FINAL PRODUCT/PROCESS CHANGE NOTIFICATION #16776Generic Copy

Issue Date: 01-Dec-2011**TITLE:** 0W635-002 Mold Compound Change in Tong Hsing**PROPOSED FIRST SHIP DATE:** 01-Mar-2012**AFFECTED CHANGE CATEGORY(S):** Mold Operations – Mold Compound**FOR ANY QUESTIONS CONCERNING THIS NOTIFICATION:**Contact your local ON Semiconductor Sales Office or <ffxxh@onsemi.com>**SAMPLES:** Contact your local ON Semiconductor Sales Office**ADDITIONAL RELIABILITY DATA:** AvailableContact your local ON Semiconductor Sales Office or <phine.guevarra@onsemi.com>**NOTIFICATION TYPE:**

Figure 1: Acoustic Microscopy Image prior Moisture Resistance test.

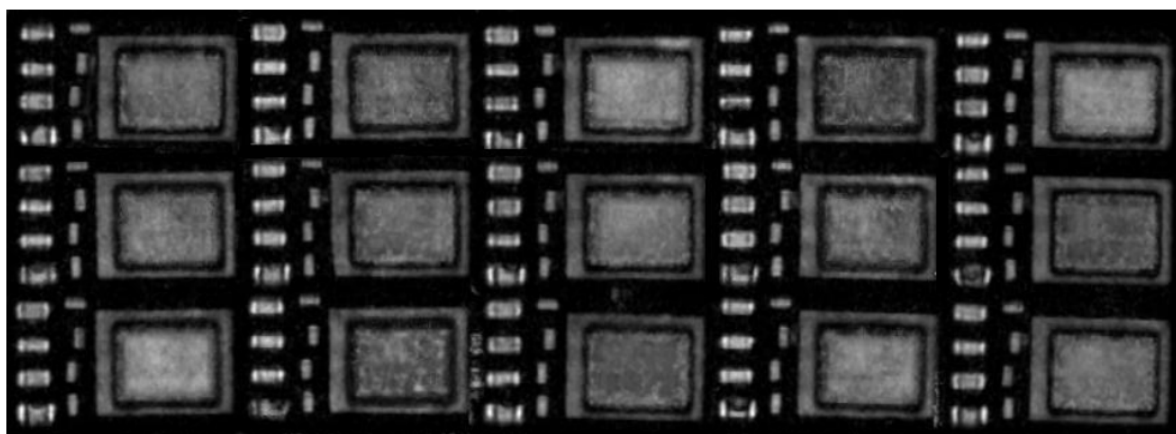
TEST	CONDITIONS	CHECKPOINTS	RESULT
Moisture Preconditioning - Bake - Humidity Soak - Reflow	125 deg C 30 deg C/ 60% RH 260 deg C	21 hrs 72 hrs 3 cycles	PASSED <i>Refer to Figure 1 and 2</i>
Scanning Acoustic Microscopy	Not Applicable	Pre and Post MSL	PASSED
Temperature Cycling	-55 deg C/ 125 deg C	250 cycles	PASSED
Unbiased – HAST	130 deg C/ 85% RH	96 hrs	PASSED
High Temperature Bake	150 deg C	500 hrs, 1000 hrs	PASSED
Electrical Testing	SW2, 25 deg C	Not applicable	PASSED
	Not Applicable	Not Applicable	PASSED
Physical Dimension Inspection	Not Applicable	Not Applicable	PASSED
Solderability test	Not Applicable	Not Applicable	PASSED

Figure 3: Reflow oven profile for SIP package at 260 deg C

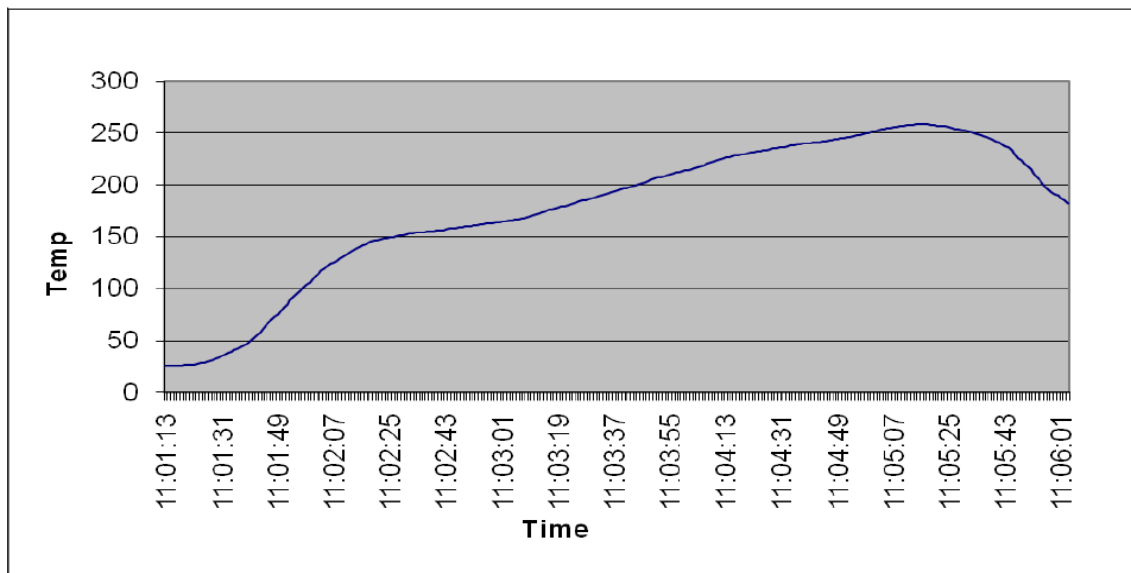
This qualification covers stacked die system-in-a-package SIP hybrid with 2 stacked die and 8 passives. Convection reflow was done during this qualification with a maximum temperature of 260°C.
